***Urgent Field Safety Notice for:
Dako Autostainer Instruments (AS480; AS100; S3800; S3400):***

Update of Autostainer Link Basic User Guide to reduce risks of staining issues due to leakage

“Instrument leakage inspection

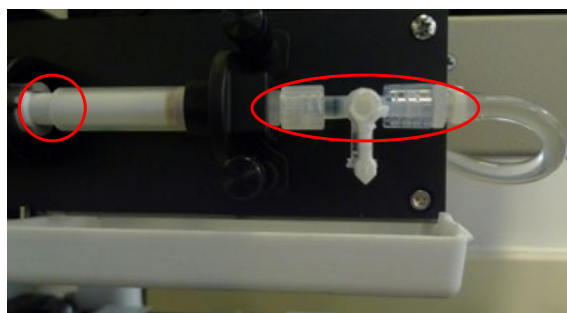
- **New section below has been added regarding inspecting the instrument for signs of leakage** (Table in “Cleaning and Maintenance Guideline Summary”, in English version: page 180, and in subsection “Instrument Leakage Inspection”, start of subsection in English version: page 186)

Inspection Interval: after each run, every month, and every three months.

Visually Inspect the left plate, and the area around the wash station for salt residues and/or liquid, see pictures below. If there are signs of unexpected salt residues and/or liquid, contact your local Agilent Technical Service representative as this might indicate a leakage in the liquid system. If leakage is observed, the slides from the run just completed must be closely reviewed for staining abnormalities.”

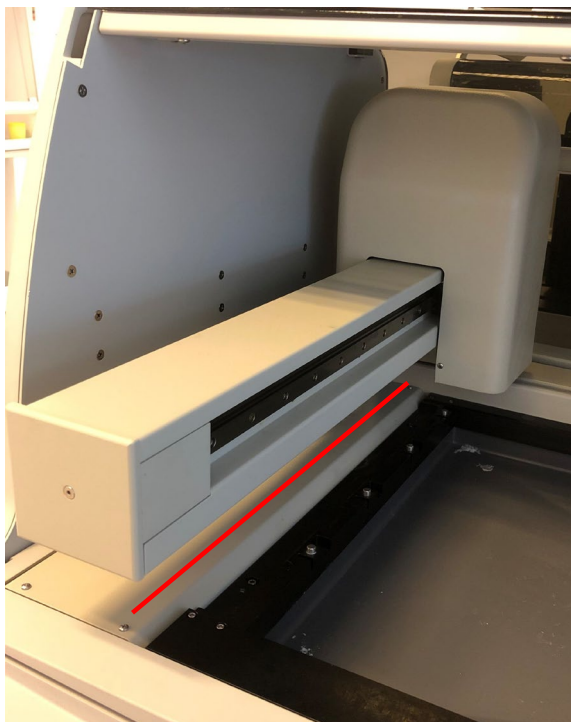
WARNING Leakage from the robotic arm or head may impact staining quality. Do not use the instrument if there are signs of unexpected leakage (salt residues and/or liquid), or if you observe leakage.

Visually inspect the syringe tray, syringe and stopcock areas highlighted in red for signs of unexpected leakage (salt residues and/or liquid).

Visually inspect the left plate, area highlighted in red, for signs of unexpected leakage (salt residues and/or liquid). This might indicate leakage from the robotic arm.

Visually inspect the area around the wash station, area highlighted in red, for signs of unexpected leakage (salt residues and/or liquid). This might indicate leakage from the z-head or too high pump pressure.
